MFN 15-056

Responses to NRC RAIs for NEDC-33376P, Revision 1 and NEDC-33377P, Revision 1 Submittal

MODEL DESCRIPTION NEDC-33376P, REVISION 1 RAIs

From Slide 11:

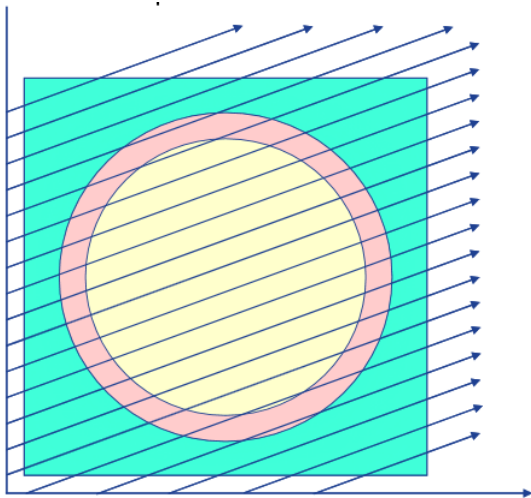
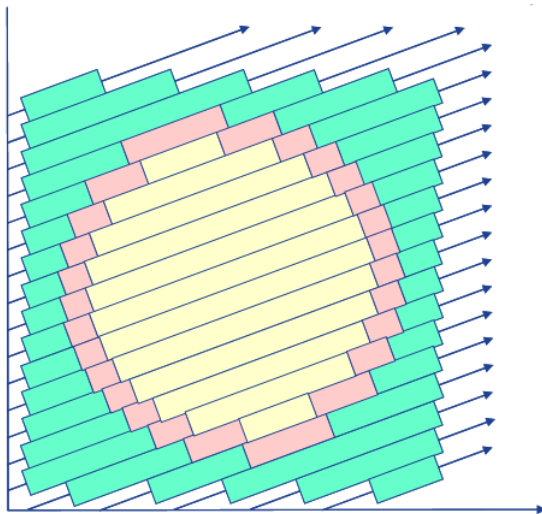
Please provide figures that are substantially similar to the figures provided in slides 11 and 12 of the LANCER pre-submittal meeting held at NRC headquarters in November 2008.

Please incorporate this information in a revision to the LANCR02 Model Description LTR.

GNF Response to RAI 18

The following figures are from the presentation given at the LANCR02 pre-submittal meeting held at NRC headquarters in November 2008.

Section 3.3 of the Model Description LTR ("Preserving Mesh Volume") will be revised to include the figures from these two slides (or substantially similar figures) as Figures 3-3 and 3-4 of the LTR.

Figure 2.1 Small Core Critical With Poison Curtains:
One Eighth Core Symmetry

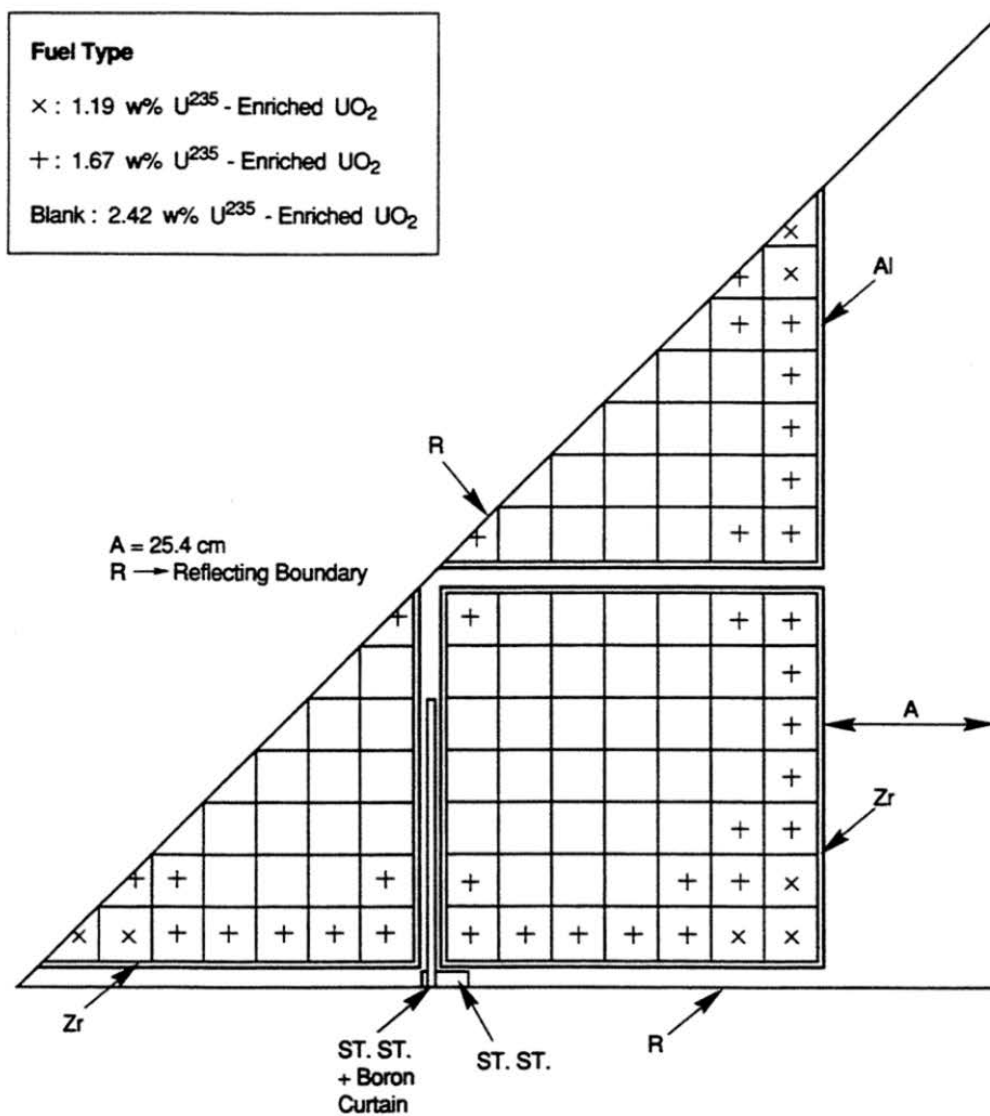
Please provide Reference 8: NEDO-32028, “MCNP: Light Water Reactor Critical Benchmarks,” dated March 1992.

Figure 2.1 shows the core with one-eighth symmetry and Figure 2.2 shows the bundle dimensions and spacings. Three features shown in Figure 2.2 have not been used in the Monte Carlo model: (1) the rounded corners shown for the bundles have been replaced in the model with right angle corners; (2) the dished fuel rods (with a lower fuel density) have not been treated separately (instead, a properly weighted average density was used for all fuel); and (3) the spacer material is not included in the model. None of these approximations is likely to affect a global parameter like the effective multiplication factor, though local quantities like fission density could be affected. The reflecting boundaries are marked in Figure 2.1.
